STAFF REPORT
PLANNING AND ZONING COMMISSION
For the February 25, 2015 meeting

TO: Planning and Zoning Commission Members
FROM: Sheena Danzer, Planning Director
SUBJECT: Master Site Plan Review request for Midtown Center at 73rd St. and University Ave.

CONCEPT #30

APPLE VALLEY CENTER
73RD STREET & UNIVERSITY AVENUE
WINDSOR HEIGHTS, IOWA

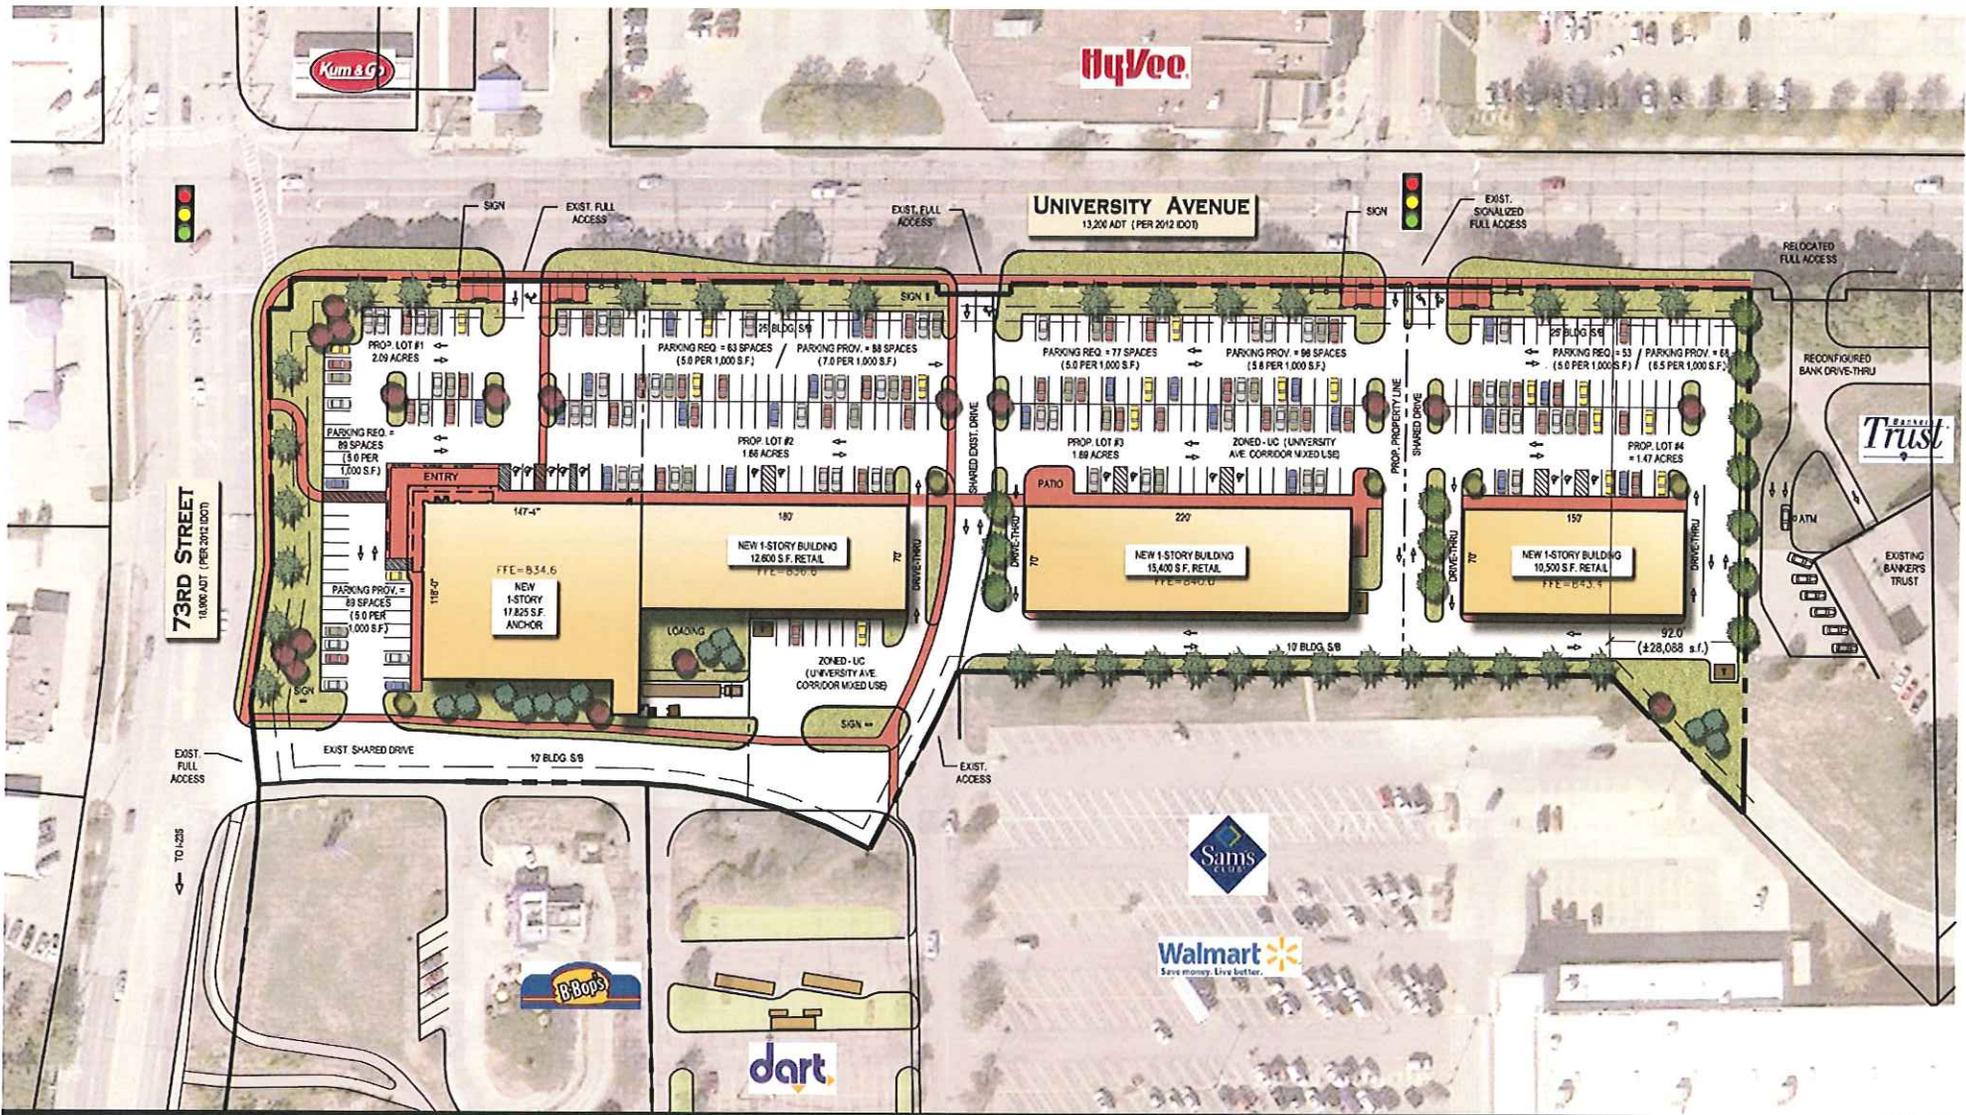
This is probably the most critical change recommended to the proposed Apple Valley Development. The current proposal has a building setback of approximately 80-100 feet. This fails to establish a strong street frontage. Since this area was identified by Windsor Heights in The Tomorrow Plan as a node/corridor location, staff would recommend that the building setback be changed to zero feet. This will create a strong street frontage and satisfy the criteria of a node development. Building the buildings to the street will begin to create spatial enclosure and provide pedestrians with direct access to store fronts.

The recommended sidewalk width for this development should be 20 feet. The wide sidewalk will provide adequate space for street trees and accommodate outdoor seating potential for business. It will also provide pedestrians with direct access to the building frontages. The recommendation for street tree placement is at approximately 30 foot increments. Landscaping budget should focus on University Avenue and 73rd Street frontages.

All parking should be in the rear of the lot with the exception of the on-street parking that should be included as part of the project. On-street parking space could be metered as a potential revenue source. This parking revenue could be used to pay for additional streetscape improvements adjacent to the development.

Windsor Heights has a very limited amount of commercial street frontage. It is in the best interest of the city to maximize the development potential of the University Avenue corridor. The current proposal does not achieve what it could if the building were arrange differently on the site. Maximizing the available street frontage will not only allow the developer to have more rent earning potential but will also maximize the city's revenue through increase tax base.

- Build buildings to the sidewalk/street;
- Provide a wide sidewalk with street trees;
- 1-story buildings should be built to accommodate the addition of upper stories in the future;
- Provide on street parking with all remaining surface parking placed in the rear of lot; and,
- Maximize valuable commercial street frontage;
